To: T10 Committee (SCSI)

From: George Penokie (Tivoli Systems)

Subject: Defining Targets/Initiators as Ports

The following show the changes in SAM-2 that would be required to change to support a port = target/initiator model.

Figure 8 — Target/Initiator hierarchy diagram

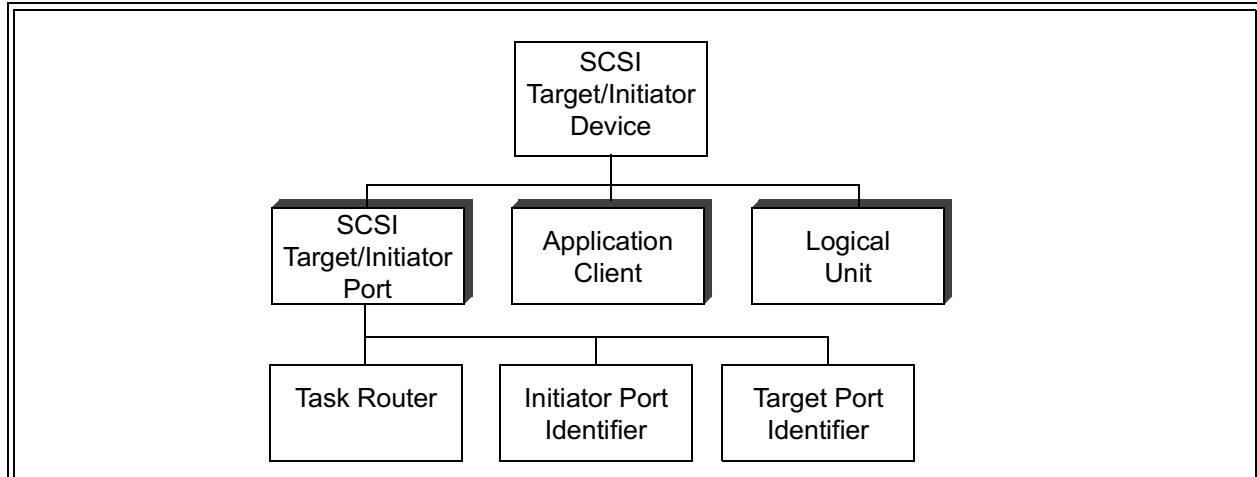
New SAM-2 section 4.7.3 SCSI target/initiator device

A SCSI target/initiator device (see figure 7) contains:

- a) one or more SCSI target/initiator ports each containing a task router, target port identifier, and an initiator port identifier;
- b) one or more logical units; and
- c) zero or more application clients.

Figure 10 — SCSI device functional models

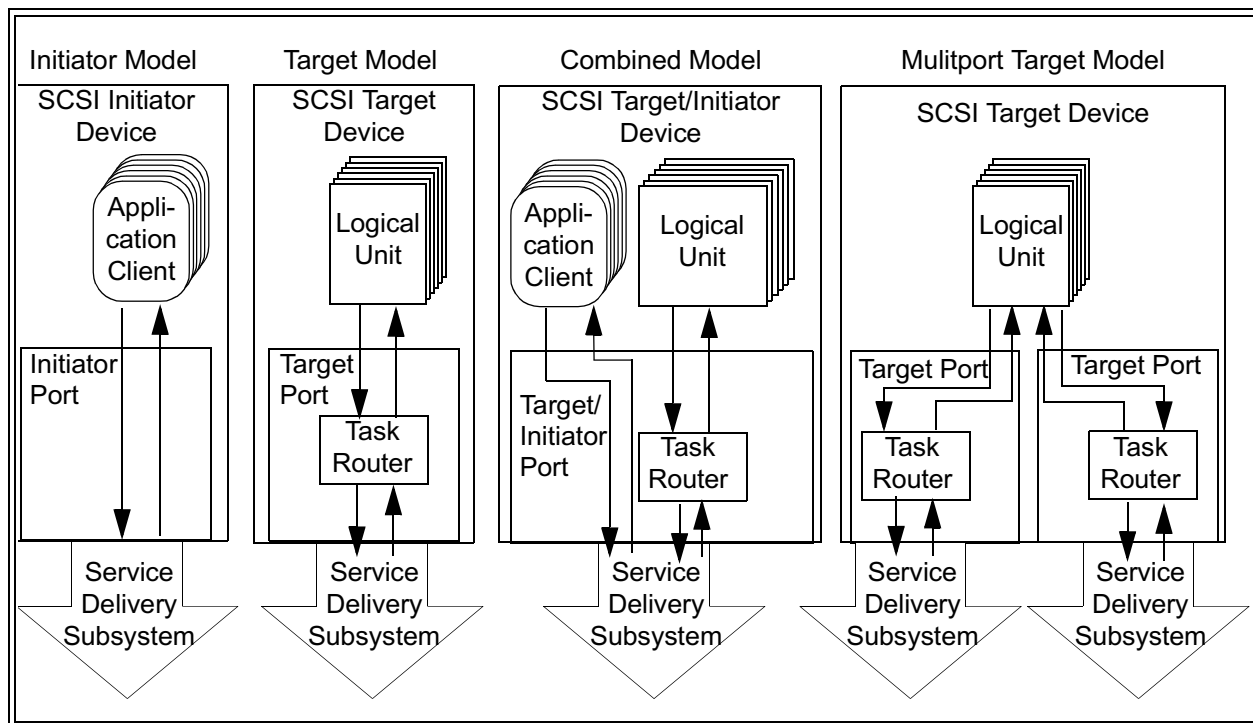
A SCSI device may contain only SCSI target ports, only SCSI initiator ports, only SCSI target/initiator ports or any combination of ports. Some of the port configurations possible for a SCSI device are shown in figure 10.

A target/initiator SCSI device is referred to by the role it's port takes when it participates in an I/O operation. When a SCSI target/initiator device receives SCSI commands or task management functions, the SCSI target/initiator device takes on the characteristics of and is referred to as a SCSI target device. When a SCSI target/initiator device issues SCSI commands or task management functions, the SCSI target/initiator device takes on the characteristics of and is referred to as a SCSI initiator device.

Figure 11 — Multiple port target SCSI device structure model

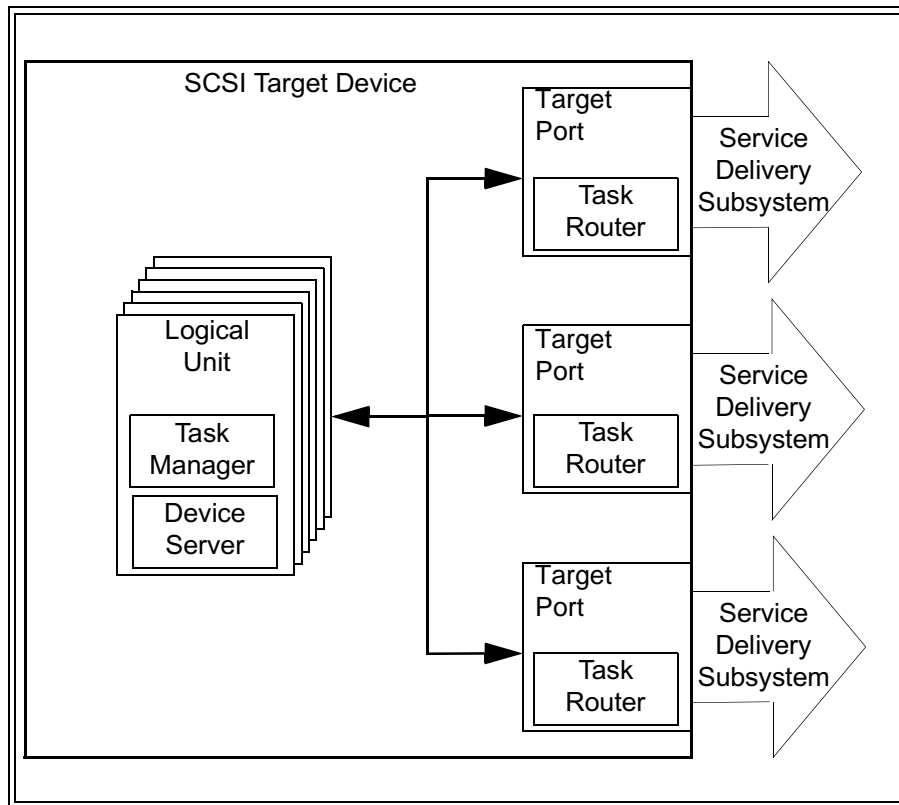
Figure 11 shows the structure of a SCSI target device with multiple SCSI target ports. Each SCSI target port consists of a task router that is shared by a collection of logical units. Each logical unit contains a single task manager and a device server.

Two-way communications shall be possible between all logical units and all SCSI target ports, however, communications between any logical unit and any SCSI target port may occasionally be inactive. Two-way communications shall be available between each task manager and all task routers. Each SCSI target port shall accept commands addressed to LUN 0 and the task router shall route them to a device server for processing. The REPORT LUNS commands (see SPC-2) shall be accepted by logical unit 0 from any SCSI target port and shall return the logical unit inventory available via that SCSI target port. The availability of the same logical unit through multiple SCSI target ports is discovered by matching SCSI port identifier values in the INQUIRY command vital product data page (see SPC-2).

Figure 12 — Multiple port SCSI initiator device structure model

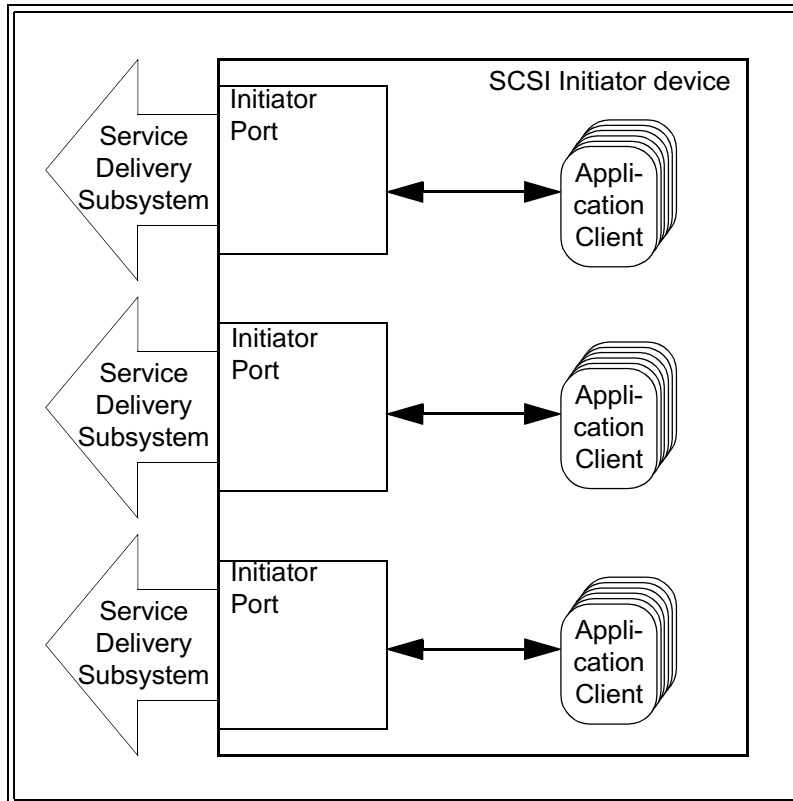
Figure 11 shows the structure of a SCSI initiator device with multiple SCSI initiator ports. Each SCSI initiator port is shared by a collection of application clients.

Two-way communications shall be possible between an application client and its associated SCSI initiator port. Mechanisms by which a SCSI target device would have the ability to discover that it is communicating with multiple ports on a single SCSI initiator device are beyond the scope of any standards in the SCSI family of standards.

Figure 13 — Multiple port target/initiator SCSI device structure model

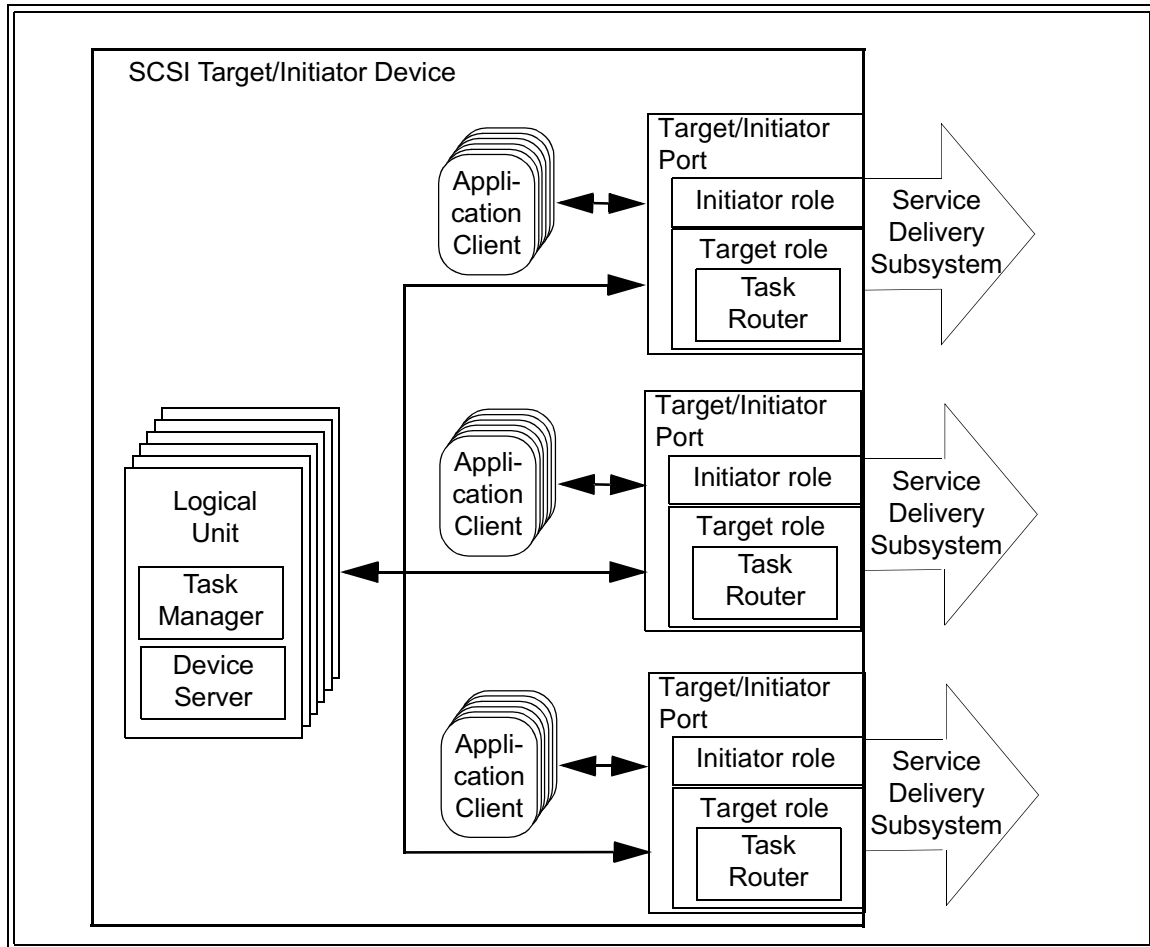
Figure 11 shows the structure of a SCSI target/initiator device with multiple SCSI target/initiator ports. Each SCSI target/initiator port consists of a task router and is shared by a collection of logical units and application clients. Each logical unit contains a single task manager and a device server.

Two-way communications shall be possible between all logical units and all SCSI target/initiator ports, however, communications between any logical unit and any SCSI target/initiator port may occasionally be inactive. Two-way communications shall be possible between an application client and its associated SCSI target/initiator port. Each SCSI target/initiator port shall accept commands addressed to LUN 0 and the task router shall route them to a device server for processing. The REPORT LUNS commands (see SPC-2) shall be accepted by logical unit 0 from any SCSI target/initiator port and shall return the logical unit inventory available via that SCSI target/initiator port. The availability of the same logical unit through multiple SCSI target/initiator ports is discovered by matching SCSI port identifier values in the INQUIRY command vital product data page (see SPC-2).
